HENDY WIND FARM: Land Off A44 SW Of Llandegley Llandrindod Wells Powys

Application for discharge of condition 28 from P/2014/0672 (APP/T6850/A/17/3176128): AIL Traffic Management Plan

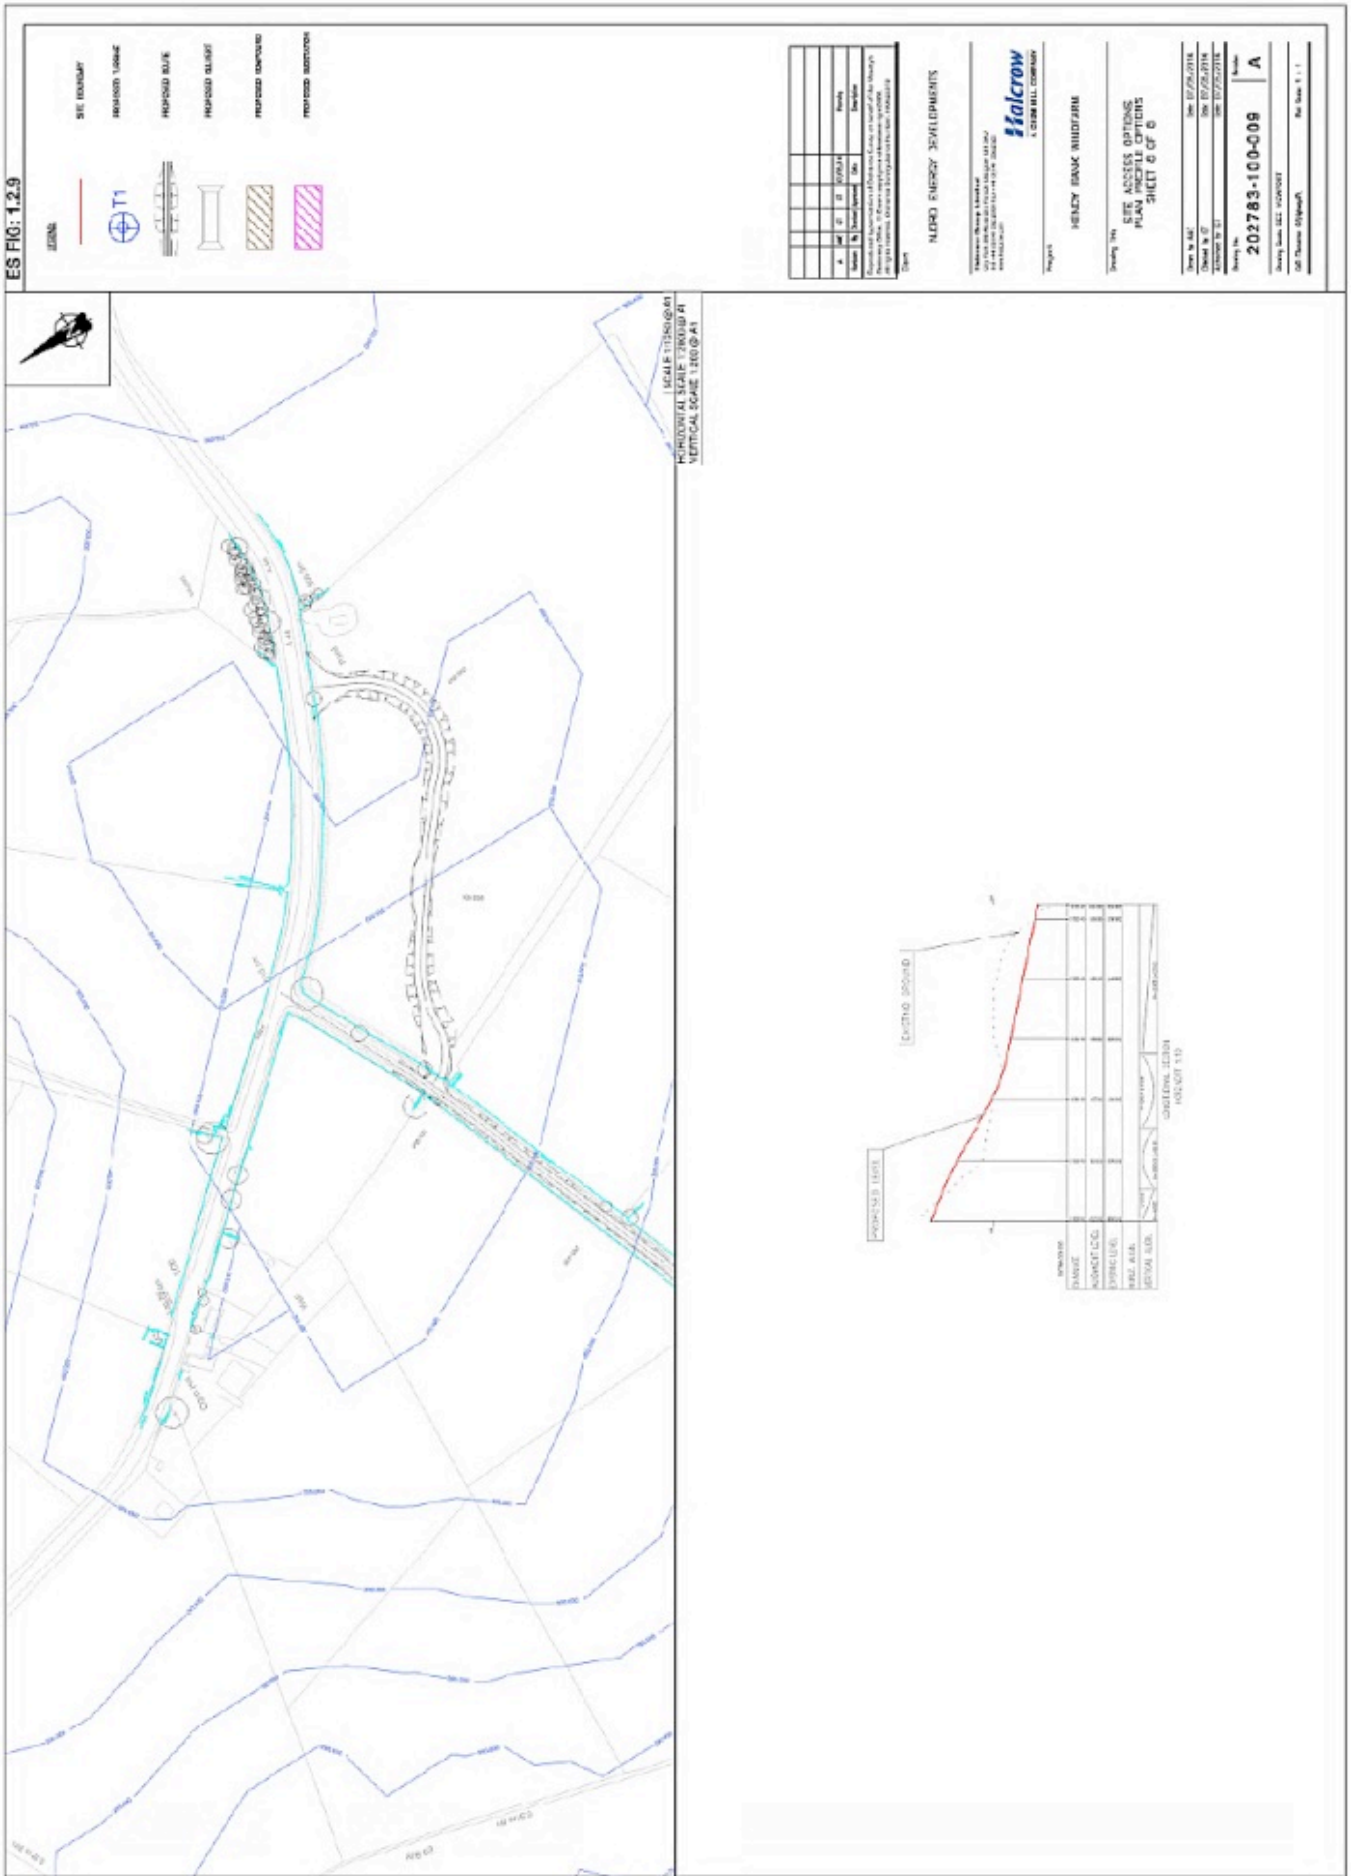
The developer only has planning permission for the construction and the entrance management described in the ES, and for AIL transport over the Southern route, but has now submitted another entirely different set of plans for access from the A44 by AILs (see plans 1 and 2 below) and, apparently abandoning the second, has actually constructed yet a third (on 17.1.19) which is in use in conjunction with the "secondary" (not permitted for AILs) route across the Common. The route in use requires planning permission, and potentially also consents from the Inspectorate under the Commons Act.

Since the new Northern diversion from the A44 has no planning permission, there is no way pre-commencement condition 28 can be discharged. Consultation on the application to discharge this condition has no power to control this development.

- 1) The new Northern diversion from the A44 requires full EIA planning permission.**
- 2) While Powys CC will no doubt require a retrospective Planning Application, and has pre-judged the issue in its intention to approve, this approval cannot be presumed and full EIA consultation is required.**
